**BCA & DDA/ACCESS ASSESSMENT REPORT**  
*Design Development Report*

**PROJECT:**  
**GUNNEDAH HOSPITAL REDEVELOPMENT**  
*Stage 1*

Date: 9 June 2023

Figure 38

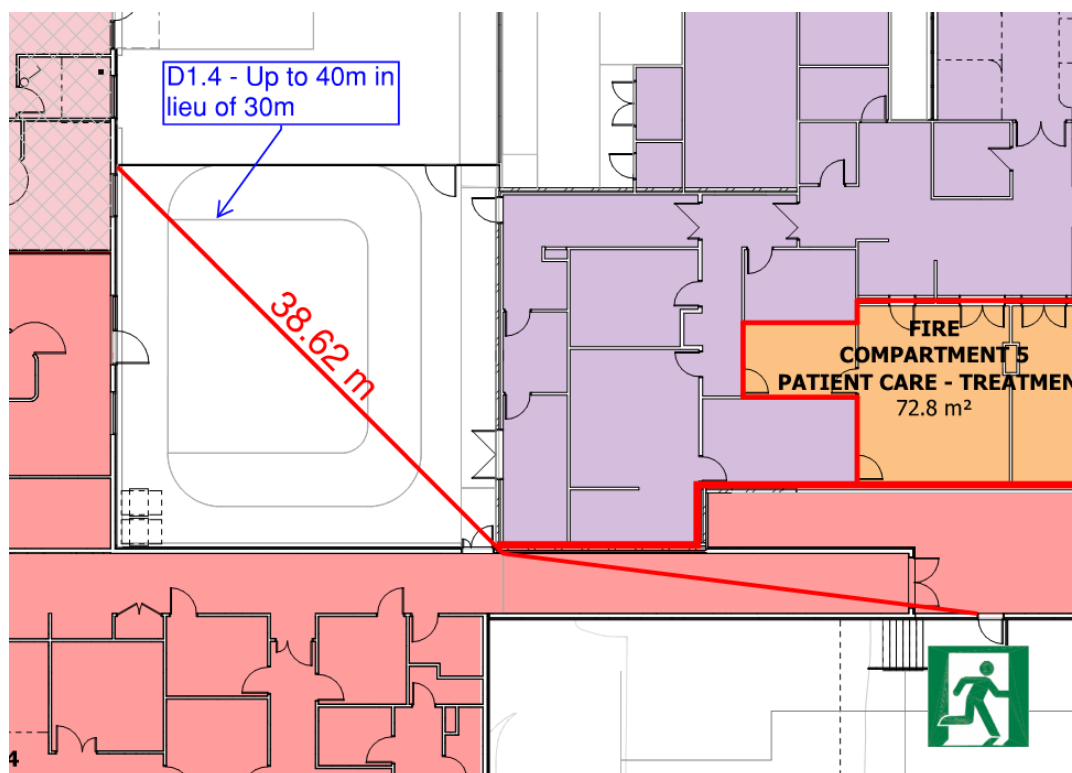
Note- no dimensions listed on plans and shall be updated so accurate assessment can occur. The below has been assessed from assumed scale only.

The birthing courtyard has up to 40m to nearest of two exits in lieu of 30m.

Figure 39

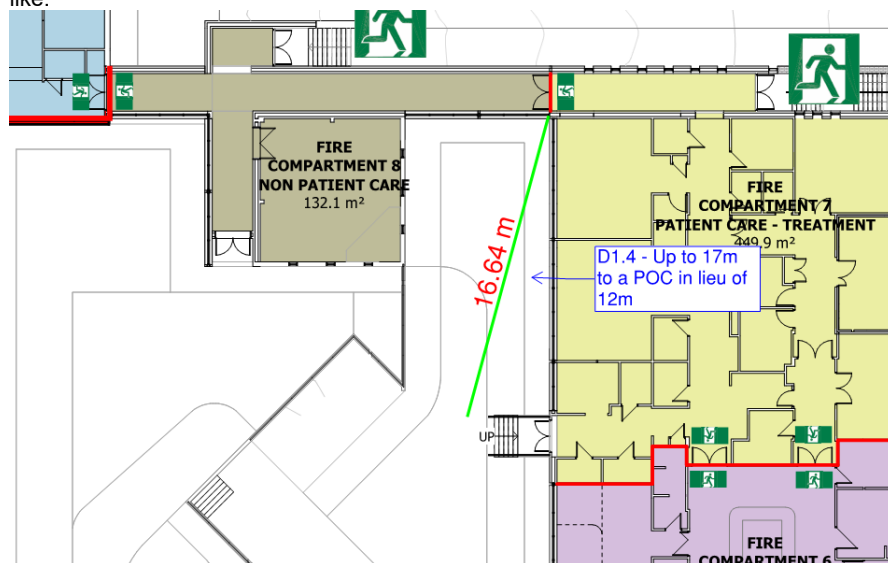
The central courtyard has numerous areas in excess of DtS limitations. The FER strategy is to permit up to 17m to point of choice in lieu of 12m and up to 40m in lieu of 30m to allow for landscape features and the like.

Figure 41

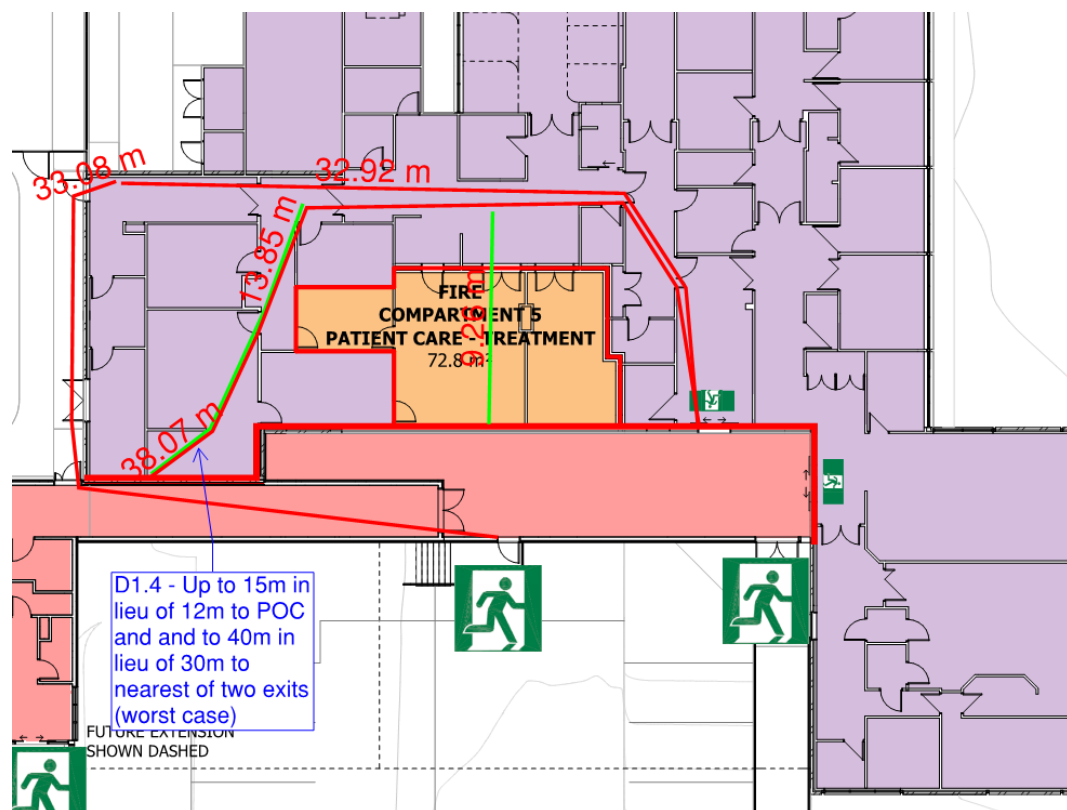
Fire compartment 5 and 6 existing egress arrangement is impacted by proposed extension and results in numerous areas of extended travel distance. Worst case (highlighted) is up to 15m to a point of choice to two exits in lieu 12m and up to 40m to the nearest of two exits in lieu of 30m. Fire compartment 6 to be included in Solution noting fire rated wall are not considered horizontal exits.

Figure 43

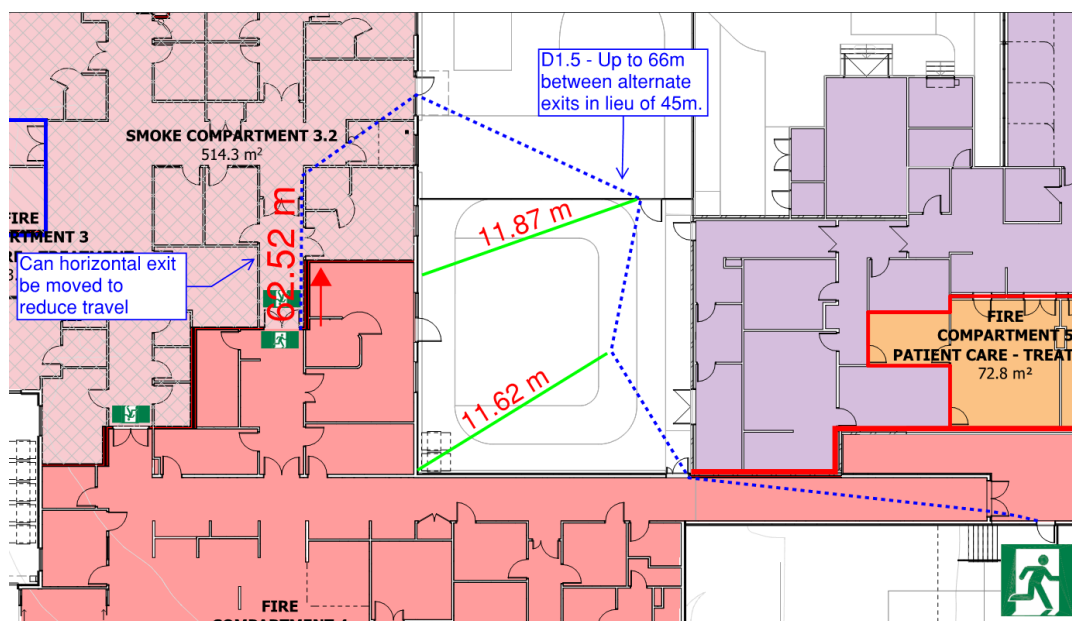
Birthing courtyard has up to 63m between alternative exits in lieu of 45m.

Figure 44

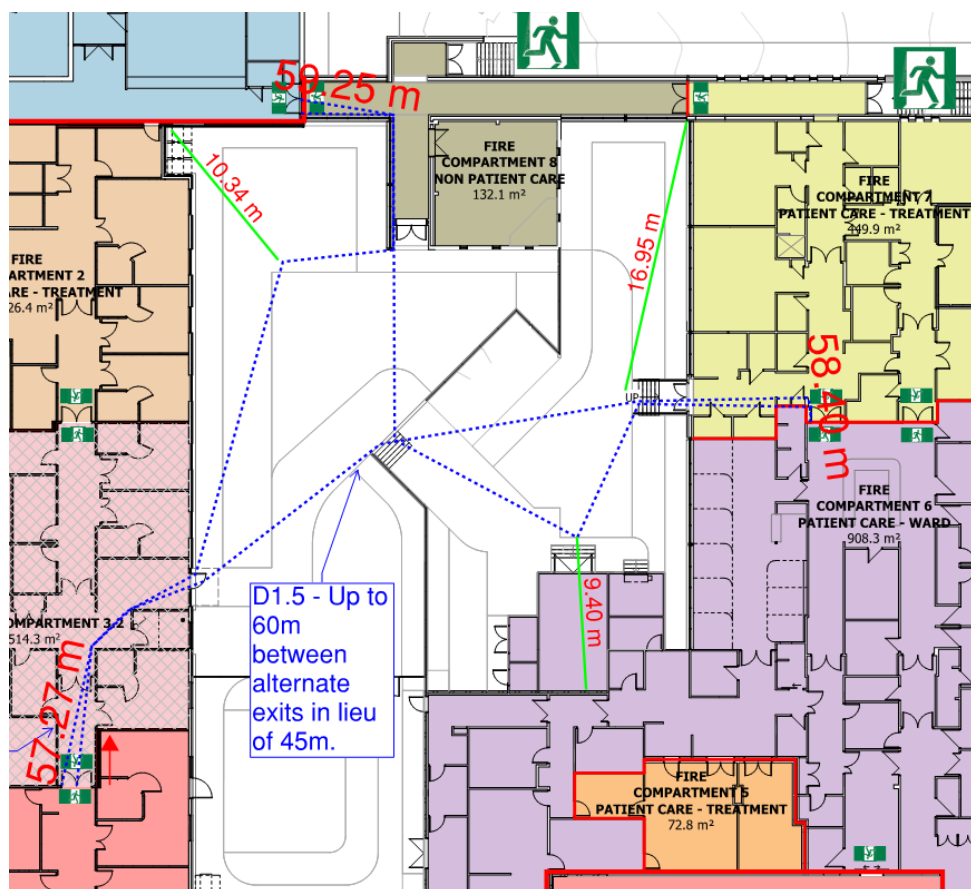
Current plans have max 60m (worst case) between alternative exits in lieu of 45m.

Figure 45

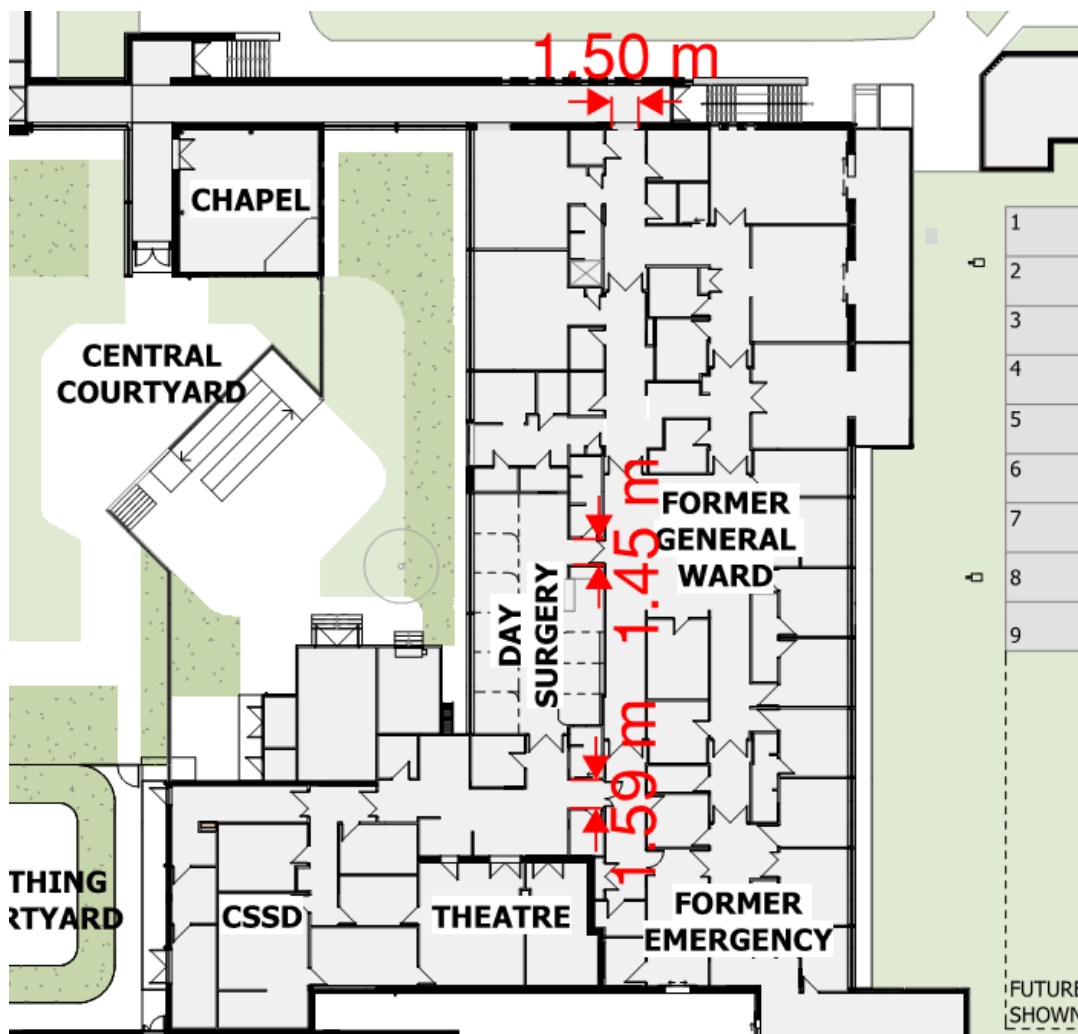
Previous plans indicated intent to re-use existing operating theatre for new works. Confirmation is required for proposed bed transportation plan. Architect to ensure clear 1.8m except for doors. Areas of concern depicted below.

Figure 49

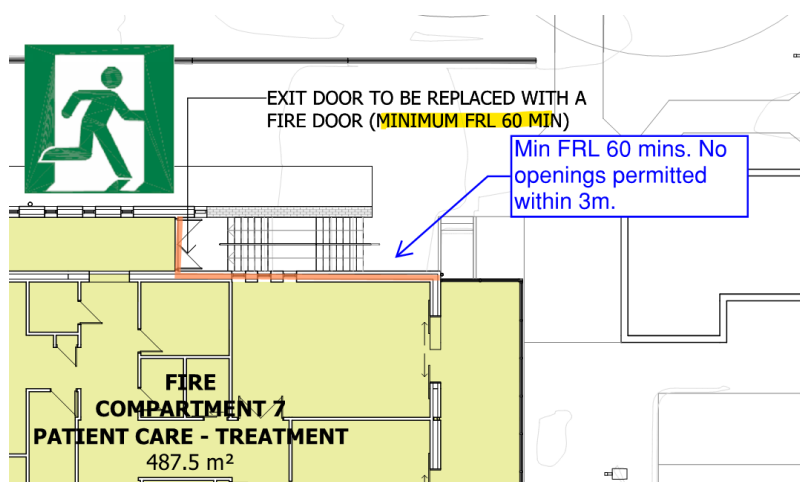
The existing external stair from fire compartment 7 is relied on for new works. Architectural plans depict door to be upgraded to FRL 60 minute fire doors. The existing glazed windows are not permitted within 3m of the exit, the minimum FRL of 60 minutes is to be confirmed or captured by way of fire engineered strategy where compliance cannot be confirmed. Refer appendix B for existing on site non compliances. Confirmation is required if the external wall with openings <3m from exit is to be rectified to comply with D1.8 or FER is to address.

Figure 50

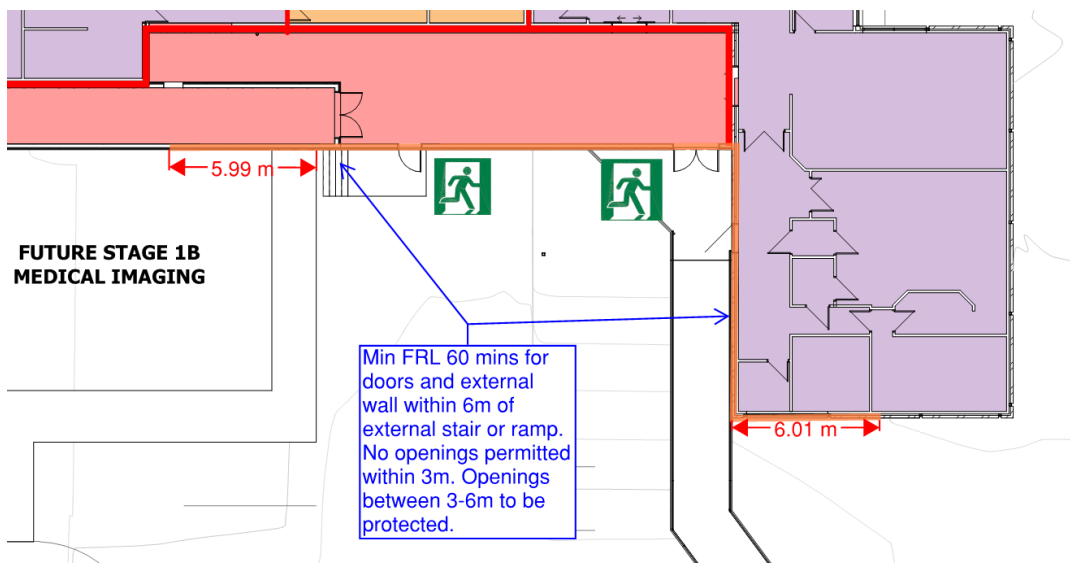
Similarly the exit stairs and ramp from patient care areas are considered an external ramp / stair in lieu of fire isolated and requires protection under BCA D1.8. Updated plans required depicting compliance, FER required to address any deficiencies.

The gradient is to be confirmed on compartment plans (see D1.10).

Figure 52

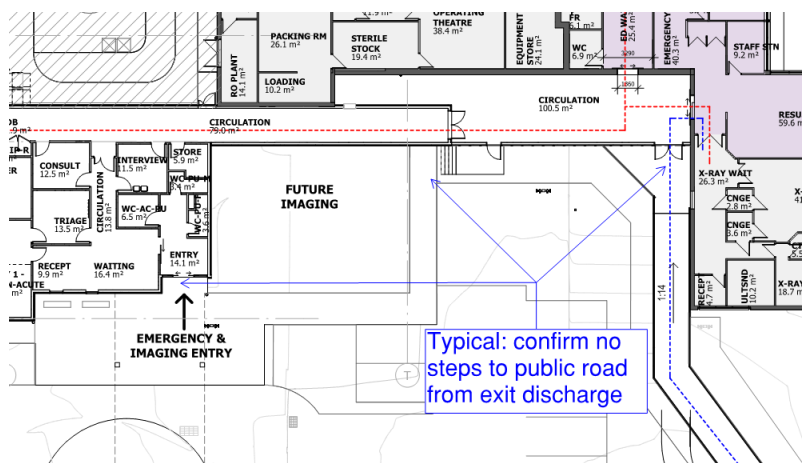
Architect to confirm if from any exit discharge point there is a step in order to reach public road. Class 9a requires only ramps. Any steps to be identified on plan for review, FER to address any area where compliance is not achieved.

Figure 54

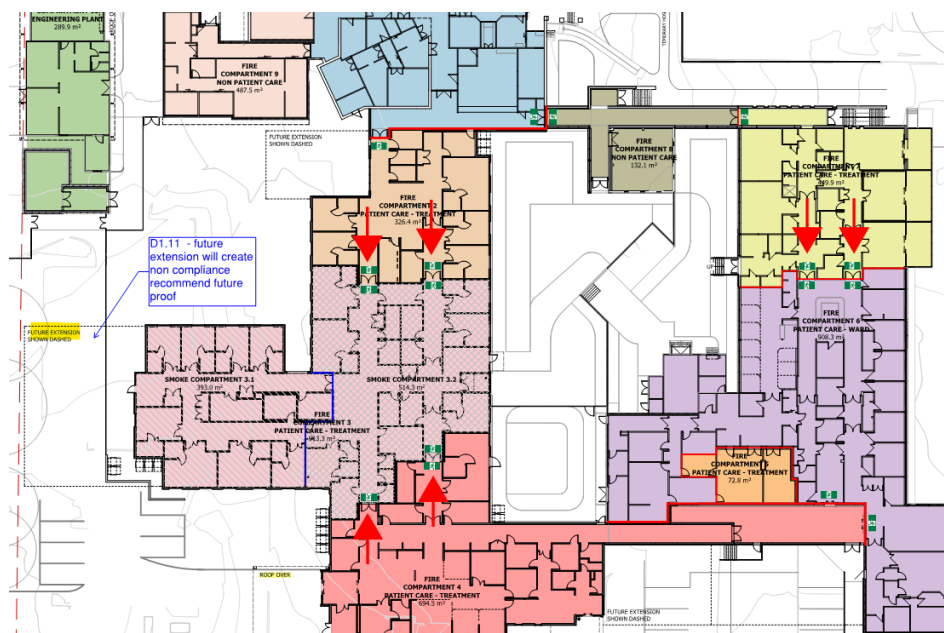
Fire compartment 7 has new works (birthing suite) which rely on HE to be addressed in FER.

Figure 58

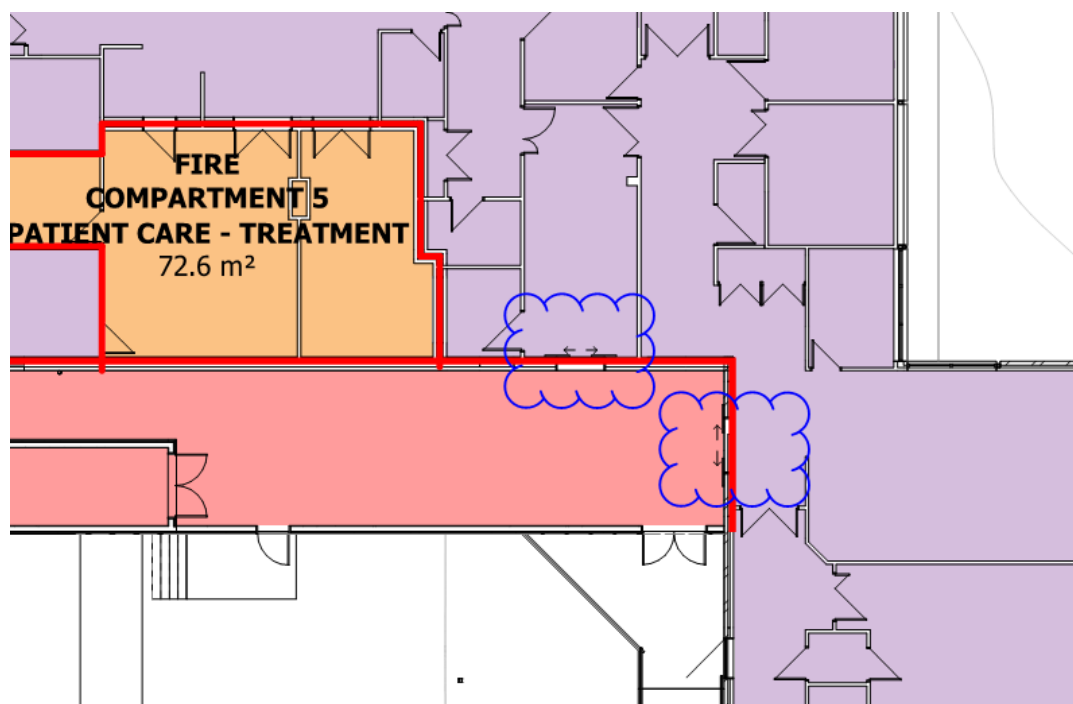
Sliding doors only permitted where it leads directly to road or open space. Sliding doors are not permitted within internal fire wall separating different types of construction serving as a required exit (HE). Updated design required.

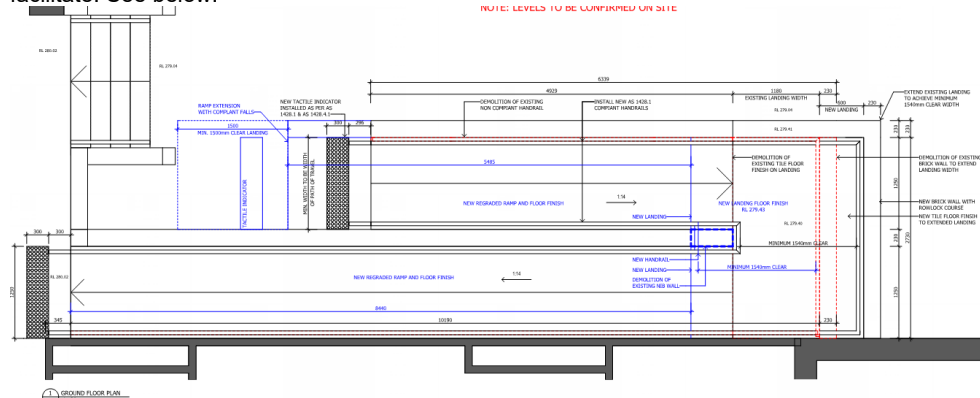
Due to reduction of scope the existing main entry is required to be upgraded in order to comply with DDA provisions. The existing ramp has been modified including access from accessible car spaces in order to facilitate. See below.

Figure 61

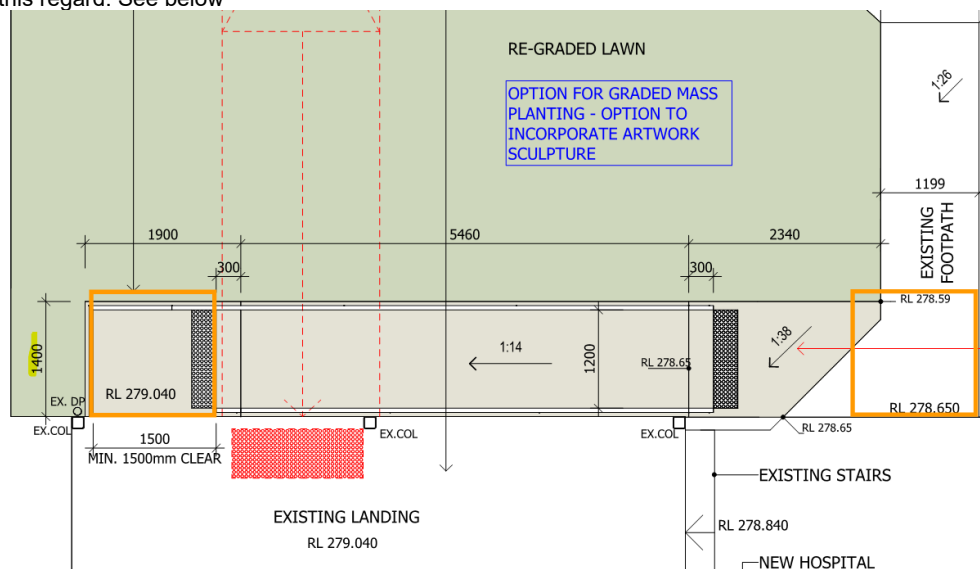
Walkways and landings require min 1.5m x 1.5m landing for 90 degree turn. Additional space is required in this regard. See below

Figure 62

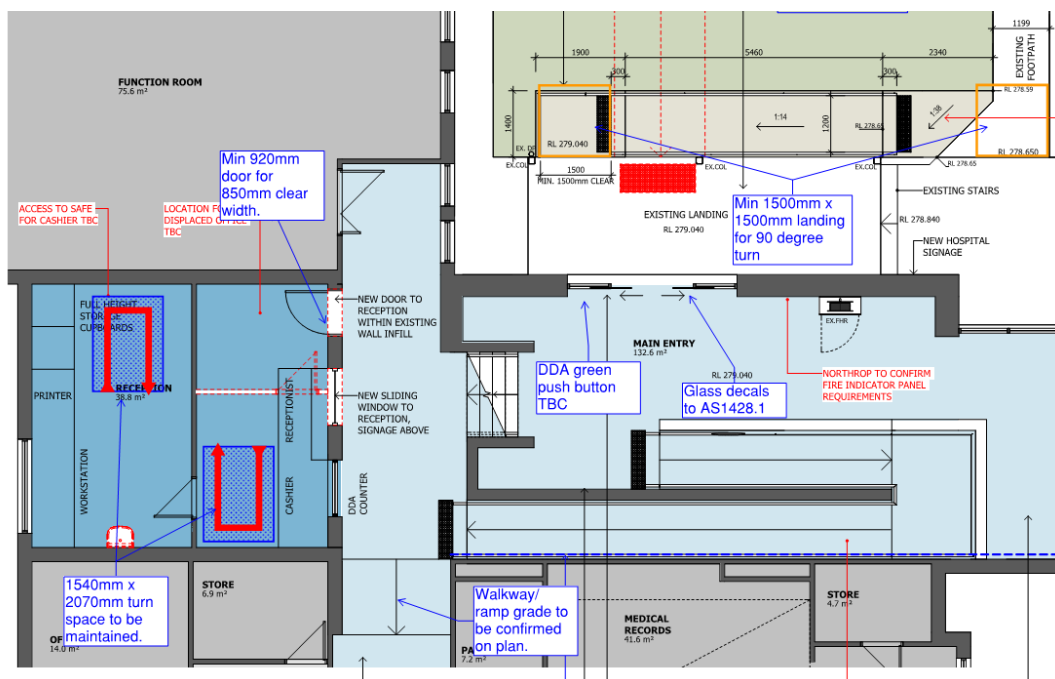
- + Min 1540mm x 2070mm turn space for reception (currently complies),
- + New door from reception to corridor to be min 920mm for 850mm clear width including min 30% door contrast and lever action hardware;
- + Gradient to be depicted on corridor walkway/ ramp to confirm handrail requirements;
- + A DDA green push button to AS1428.1 is required for glass auto doors. The button shall be no closer than 500mm from an internal corner and be mounted at a height between 900 – 1.2m from FFL.
- + Glazing decals required in accordance with AS1428.1.

Figure 63

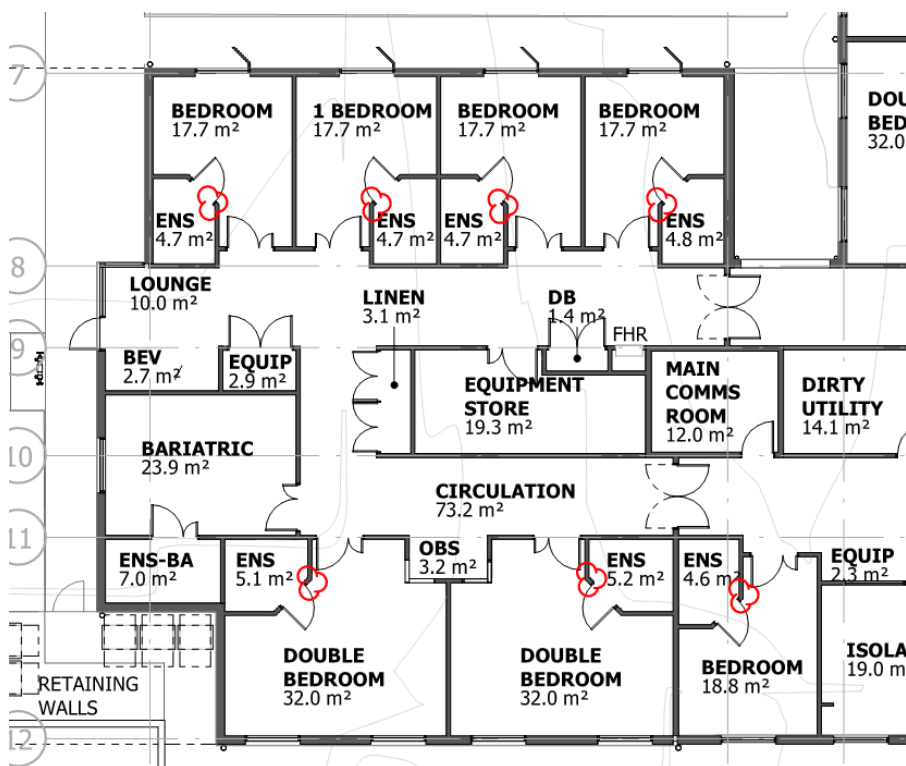
Access is required to and within all areas which extends into resident ensuite. Confirmation is required if required latch side clearance will be achieved or this will be addressed by way of performance solution. Typical scenario below (see circulation space below also).
